# Core Path Report for C510 Cardross Shore Path

## 1. Proposed Core Path

Murrays Crossing (SD 38)

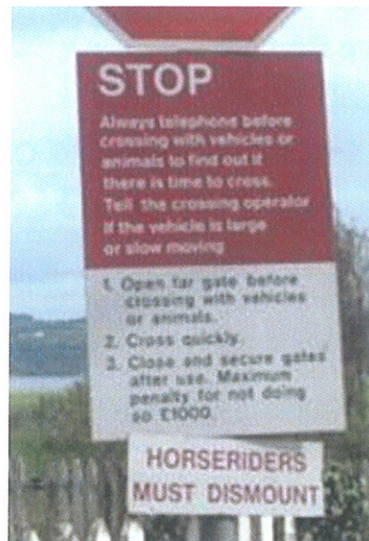
Cardross Community Council state the route goes through a private unmanned level crossing with pedestrian gates that are unsuitable for a number of user groups- horses, push chairs etc.,

Robert Laird- states the route uses a narrow single track road that used for access to fields with farm machinery, the road has narrow verge with deep ditches, goes through a private unmanned level crossing with pedestrian gates that are unsuitable for a number of user groups- horses, push chairs etc.

C510	Object	This new path goes through a locked and unmanned private high speed west highland line railway crossing with small pedestrian gates. This crossing is unsuitable for horses, cyclists, buggies or unaccompanied children.
C518	Object	This new path is impassable.
	Support	We support all other paths in the Cardross area

**Level Crossing** - Network Rail have not objected to the designation of this route which crosses the rail line. The signage on the crossing indicates that Network Rail is aware that it is used by horse riders and guidance is provided to them for the use of the crossing. There does not appear to be any reason that the crossing could not be used by most users although riders and some others would need to open the crossing gate which would require them to call the Crossing Operator for which a telephone is provided on the crossing.
